On Transmit Power Levels

D1.2 Tx Power Range

Figure 149–40—Transmitter Power Spectral Density, upper and lower masks

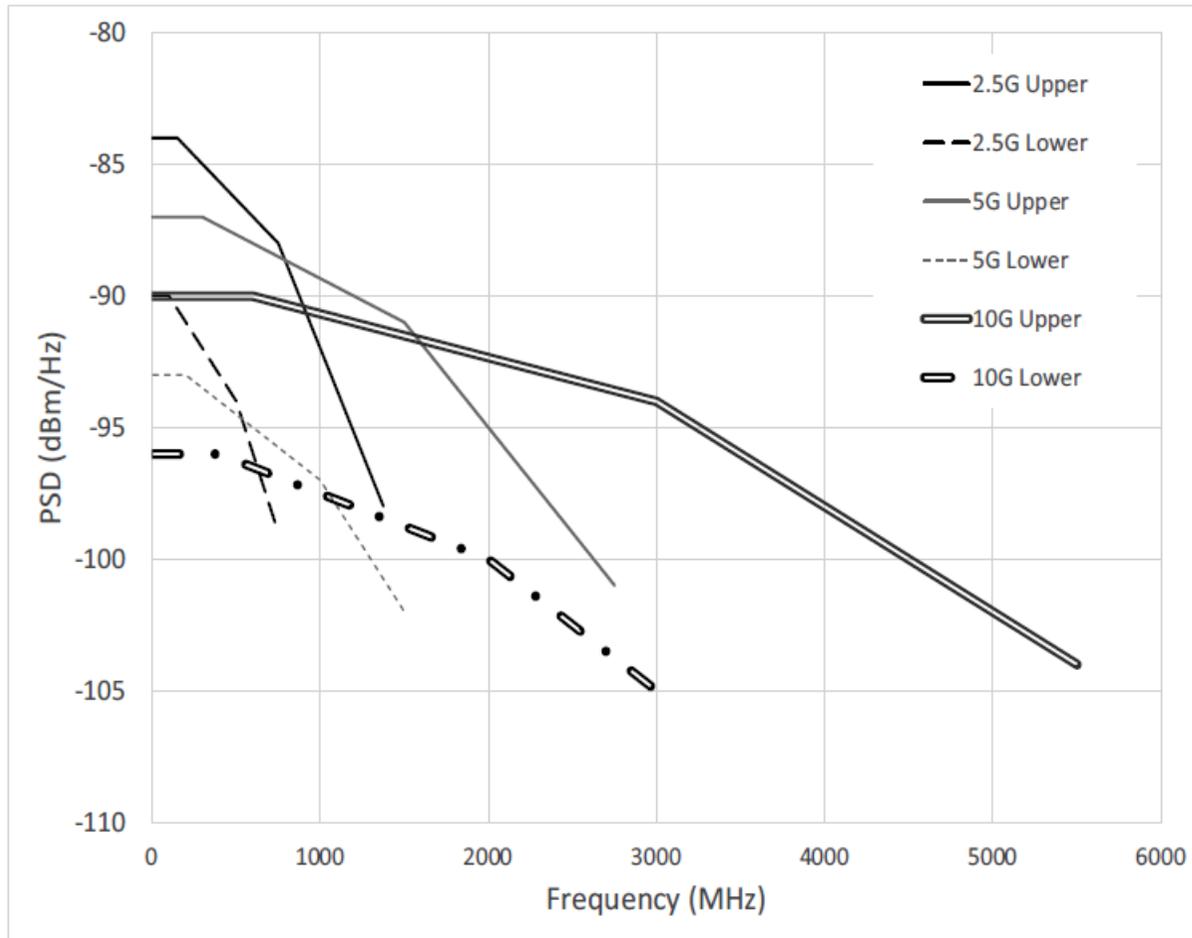
- Nominal Tx power = 1.43dBm
 - 1Vpp
 - 100 ohm load
 - PAM4
- Upper limit line \approx 4.1dBm
- Lower limit line \approx -3.8dBm

MGBASE-T Tx PSD

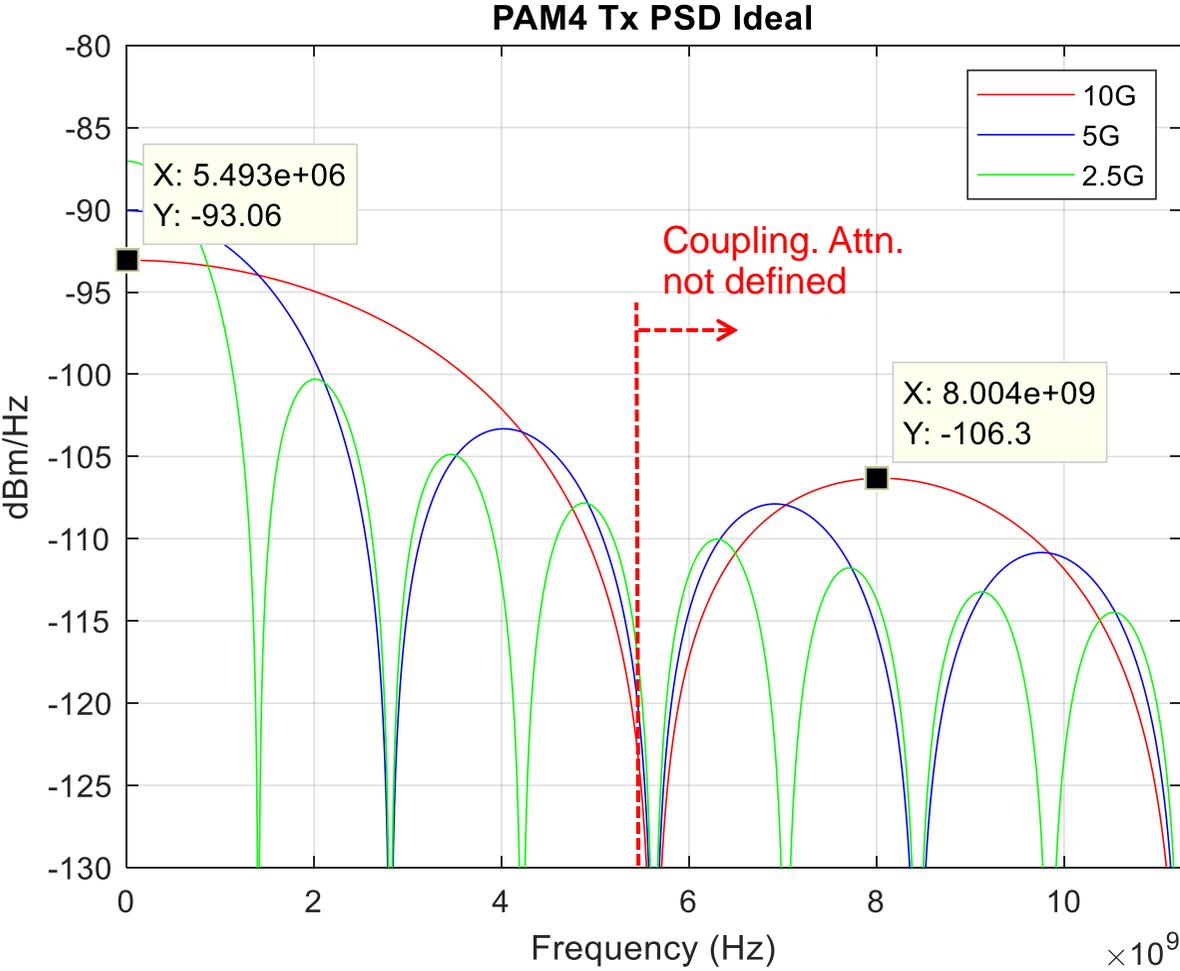
- Without analog or digital filters, the 1st sidelobe is only 13dB lower

Coupling Attenuation

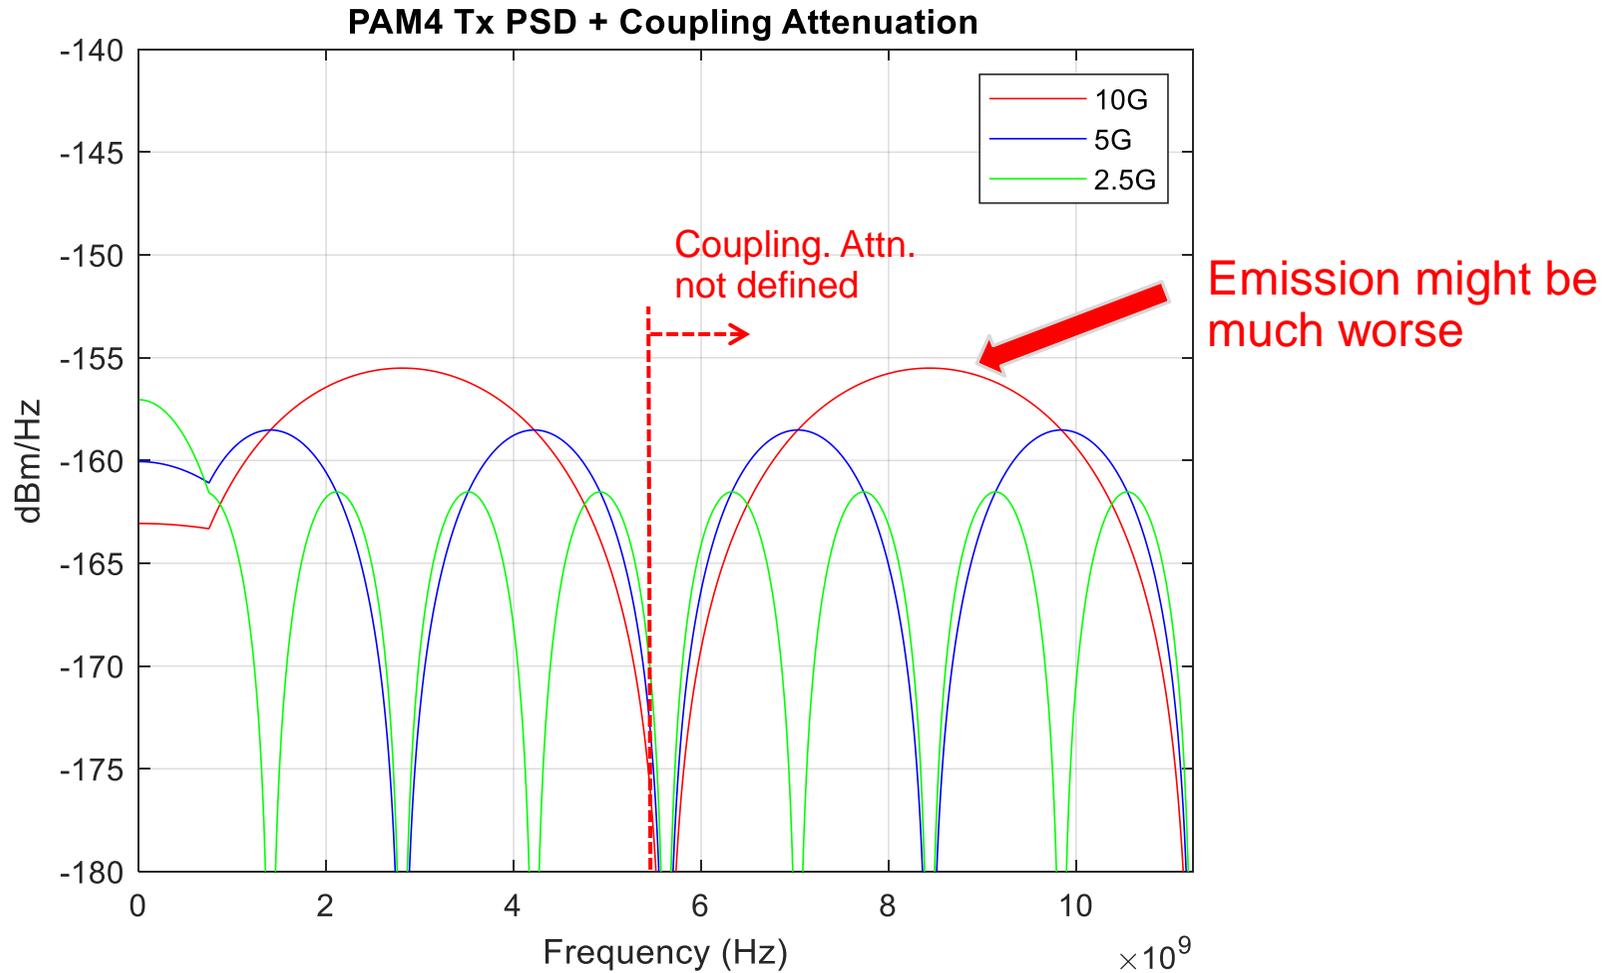
- $F_{\max} = 4000 \times S$ (Equation 149-18) ?? Or 5.5GHz (Figure 149-44)??
- In either case, it is undefined above 5.5GHz
